As this application was the largest application to come forward in the parish SPC employed 'Impact Planning Services' and 'Landscape Planning & Landscape Architecture Services' to assist us in drafting our detailed response to Babergh Planning – those reports should have been read in conjunction with our response. Our original response was made Aug'21. However, given the passage of time and the many additional documents uploaded since that time we submitted an updated response to reflect the contents of those additional documents in Nov'22. This document contains a summary of our previous objections and comments on the Planning Officers 130 page '**Public Document Pack**' submitted to the Babergh Planning Committee.

**Sproughton PC OBJECT to this application and feel strongly that this particular planning application should not be considered at this time due to the delay of the emerging BMSDC JLP partly due to the associated work on the spatial strategy and site allocation/assessment required. This site has been put forward in the new plan but does not exist in the current local plan. This site should be evaluated in accordance with the current valid local plan as per the guidance

Figure 15.16: LA116 Sproughton options for sustainable development

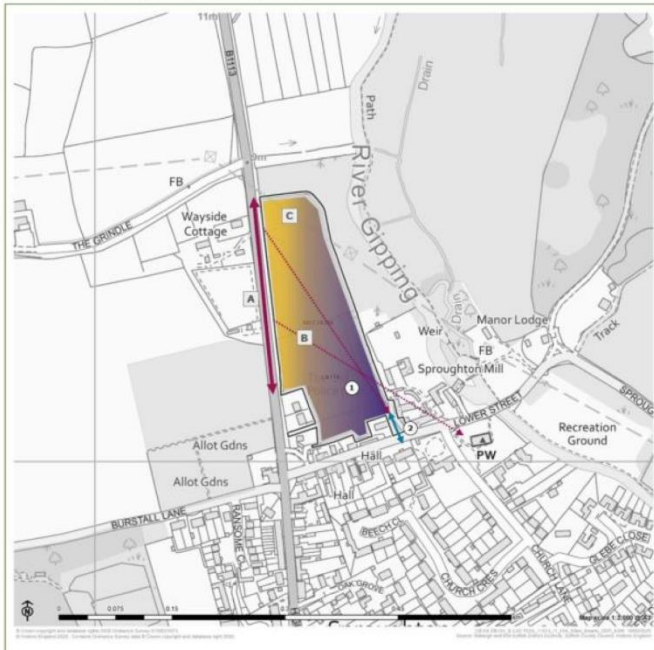
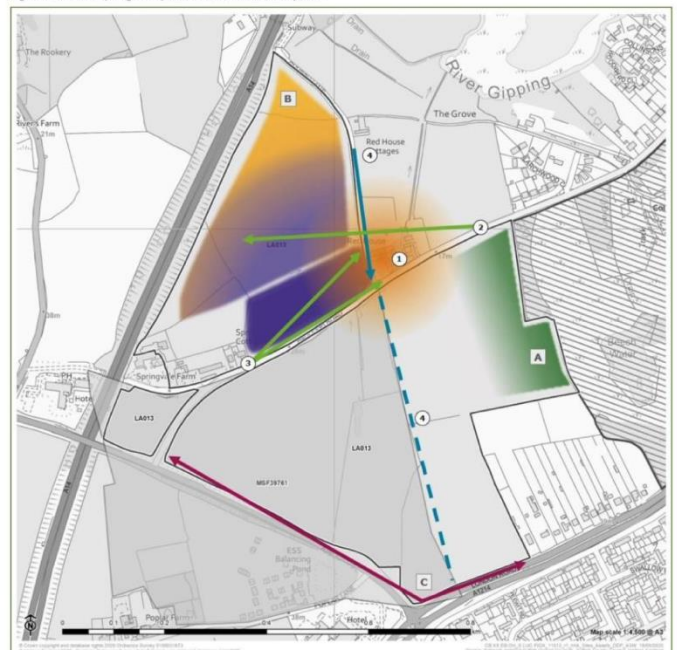
The LUC Heritage Impact Assessment is an adopted document by BMSDC with the JLP. There were four sites that acquired the highest score level of Medium to High adverse impact. One was the Hopkins Homes site and another was this application site. The report quite clearly and graphically by site plan demonstrates that development on the valley side/ridge to the west of Red House would present the highest level of harm. The adverse heritage impact on this site therefore represented the highest level of heritage harm assessed by the JLP across the BMSDC and matched the Hopkins Homes site in this respect.

This is very relevant information because the Hopkins homes site was rejected twice by the planning committee and subsequently rejected on appeal with reference to this report, and for similar grounds as our objections to this application. We feel the Planning Committee should be aware of this information.

Plan diagram showing extent and severity of the adverse heritage impact on Hopkins Home site and from same report the plan diagram for this application abstracted from the BMSDC adopted LUC Heritage Impact Appraisal for proposed JLP sites.
